MARIAN ELMORE SUBDIVISION

APPLICATION NUMBER 4 DATE November 21, 2013

REQUEST Subdivision

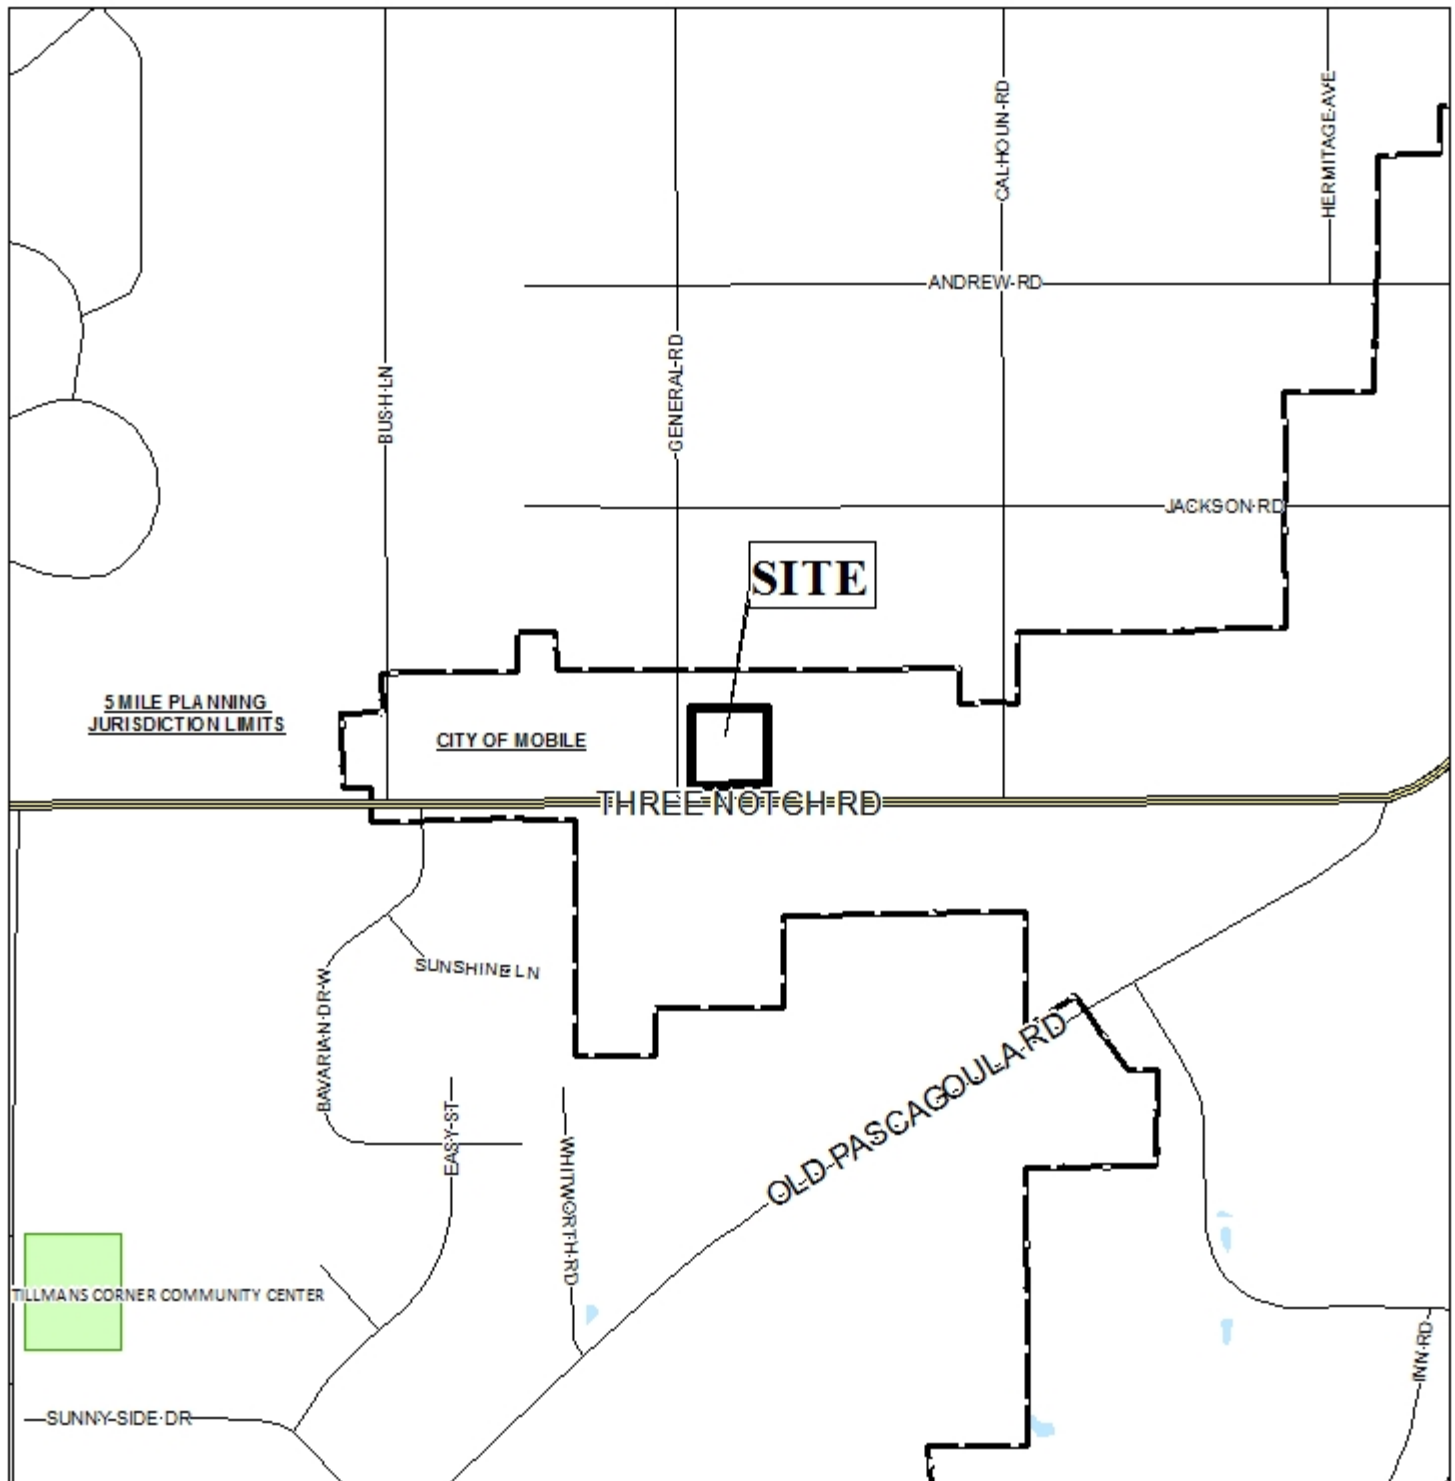
The proposed Lot 1 has frontage on General Road, a minor street that provides approximately 200 feet of curb and gutter. General Road is depicted with an adequate 50' right-of-way, and no additional dedication would be required. Both proposed Lot 1 and Lot 2 have frontage on Three Notch Road, which is shown as a major street on the Major Street Plan component of the Comprehensive Plan. The preliminary plat submitted indicates that Three Notch Road has a current 80' right-of-way along the property; however, a minimum of 100' right of way is required by the Major Street Plan. Therefore, dedication of sufficient right-of-way along Three Notch Road to provide 50' from centerline will be required.

Currently, the proposed Lot 1 and Lot 2 are developed with one curb cut each to Three Notch Road. Lot 1 also has three curb cuts to General Road. Because access management is a concern, Lot 1 lot should be limited to one curb cut onto General Road, with the size, design and location to be approved by Traffic Engineering, and in conformance to the greatest extent possible with AASHTO standards.

The preliminary plat depicts the 25-foot minimum building setback line from the right of way line of Three Notch Road and General Road. As dedication of right-of-way will be required, this should be adjusted on the plat to depict the revised dedicated frontage along Three Notch Road. The corner radius on General Road and Three Notch Road should also be adjusted to reflect the required dedications.

While this is a subdivision application there is a Zoning Ordinance related issue that should be addressed. The proposed Lot 2 illustrates two existing structures on a single building site, which is not allowed by the Zoning Ordinance without an approved Planned Unit Development (PUD). Because the site is located within the city, the Zoning Ordinance requires a (PUD) to allow multiple structures on a single site. If approved, it should be noted the site would create a zoning violation, thus a PUD application should be required.

- 1) revision of the plat to reflect dedication of sufficient right-of-way to provide 50' from the centerline of Three Notch Road;

- 2) submission of a Planned Unit Development application for Lot 2;
- 3) placement of a note on the Final Plat stating that Lot 1 and Lot 2 are limited to one (1) curb cut each to Three Notch Road, and Lot 1 is limited to one (1) curb cut to General Road with the size, location, and design of all curb cuts to be approved by Traffic Engineering and conform to AASHTO standards;

- 4) adjustment of the 25-foot minimum building setback line to be measured from the dedicated right-of-way along Three Notch Road;
- 5) revision of the corner radius on General Road and Three Notch Road should be illustrated to reflect the required dedication;

This application was heldover from the October 17th meeting to allow the applicant to submit a revised plat. The revised plat illustrates right-of-way sufficient to provide 50' from centerline of Three Notch Road. The revised plat also depicts the provision of a corner radius on General Road and Three Notch Road. The proposed Lot 1 does illustrate the 25' minimum building setback line as measured from the dedicated right-of-way along Three Notch Road. However, the proposed Lot 2 has two existing structures, one of which is located within the required 25' minimum building setback, thus a 10' minimum building setback line is illustrated on the plat. It should be noted that a 25' minimum setback would only impact new construction or expansion on the site.
